CITY OF KIRKLAND
NOTICE OF DECISION
REASONABLE USE EXCEPTION PERMIT

Permit Application: FANAIYAN GOAT HILL 2 REASONABLE USE EXCEPTION
([SAR19-00591](#))

Location: [11662 91ST PLACE NE](#) (see Attachment 1)

Project Description: The applicant is requesting approval of a reasonable use exception permit to allow construction of a single-family residence within a Category IV wetland buffer (see Attachment 2). With the exception of approximately 665 square feet along the west side of the property, the site is encumbered by critical area and critical area buffer. No portion of the new residence will extend into the sensitive area.

Figure 2. Revised Proposed Site Development Plan (Source: ZK Architecture, LLC 2022)

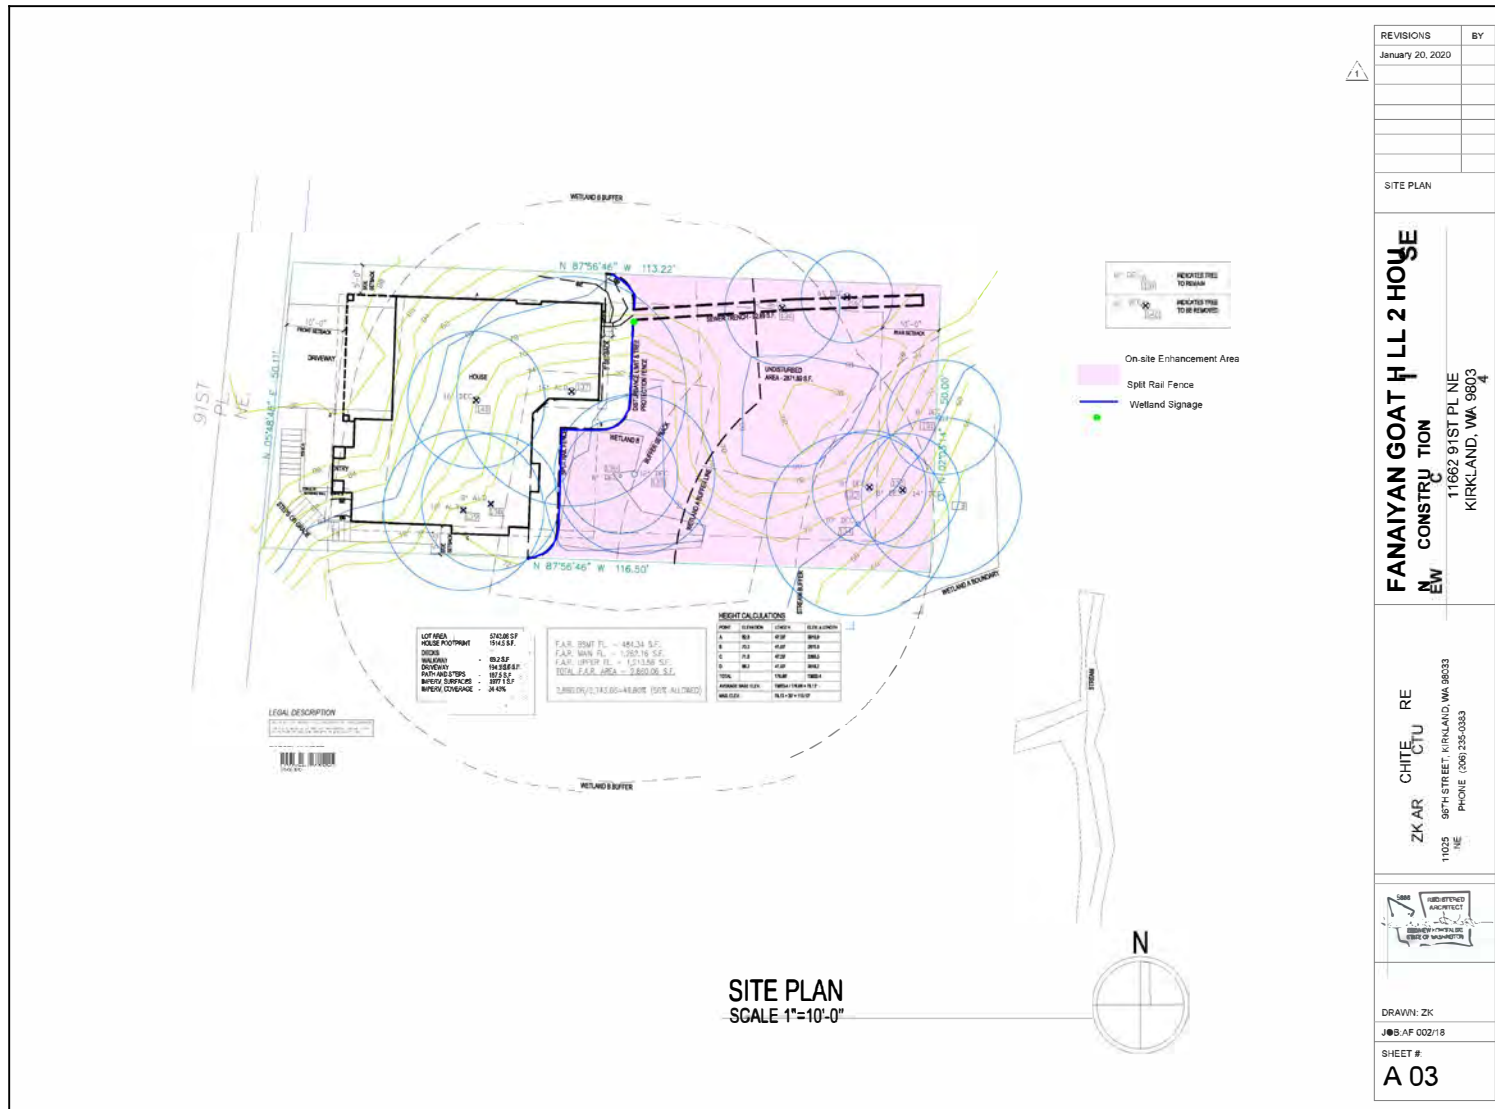
The site plan was updated to include a sanitary sewer line through wetland buffer in the northeast quadrant of the property. The updated Site Plan includes TESC sheet 1 of 4; it shows a disturbance totaling approximately 104 square feet (52-feet long by 2-feet wide) for installation of the sewer line. No easement for the sewer line is identified.

Section 3.2 of the Mitigation Report states that the enhancement planting area was reduced by 158 square feet, from 3,030 to 2,872 square feet. This reduction is not evident in the hatched enhancement area on the provided site plan (Sheet A 03). The proposed planting has been reduced based on this smaller enhancement area. Although the proposed plant schedule is appropriate for a 2,872 square foot area, the reason and location(s) of the 158 square feet reduction is unclear. It is not itemized in the submittal. Otherwise, the site plan does not differ significantly from the previous plan and enhancement planting covers the remainder of the property.

TWC stated that wetland buffer impacts were not updated to account for the sewer line; however, as discussed in the mitigation plan and shown in Figure 2 of the mitigation plan, the sewer line is within the area classified as disturbance area and is therefore included in the wetland buffer impact calculations. In fact, the footprint of the house was reduced so that the disturbance area remained at 50% of the lot size (as required under Kirkland Zoning Code [KZC] 90.180.5.c). The sewer line will be a hand dug trench; thus, the width of the disturbance area associated with the sewer line is approximately 2 feet. Because this is a private sewer line, within a designated disturbance area, a maintenance easement is not required.

The enhancement area in Figure 2 of the mitigation plan purposefully includes the disturbance area associated with the sewer line. That is because this area will be planted with native herbaceous plants and will therefore be enhanced. The non-disturbance area is the only area that will be subject to the maintenance and monitoring requirements described in the monitoring plan, and as amended in this letter. TWC commented that the non-disturbance area was reduced by 158 square feet; this reduction is due to the requirement to have the sewer line be designated as part of the disturbance area.

The sewer line is within the area classified as disturbance area, as shown in Figure 2 of the mitigation plan. The mitigation plan clearly defines and quantifies the disturbance area and non-disturbance area and discusses the enhancement of the non-disturbance area. Thus, we do not believe further clarification is needed.
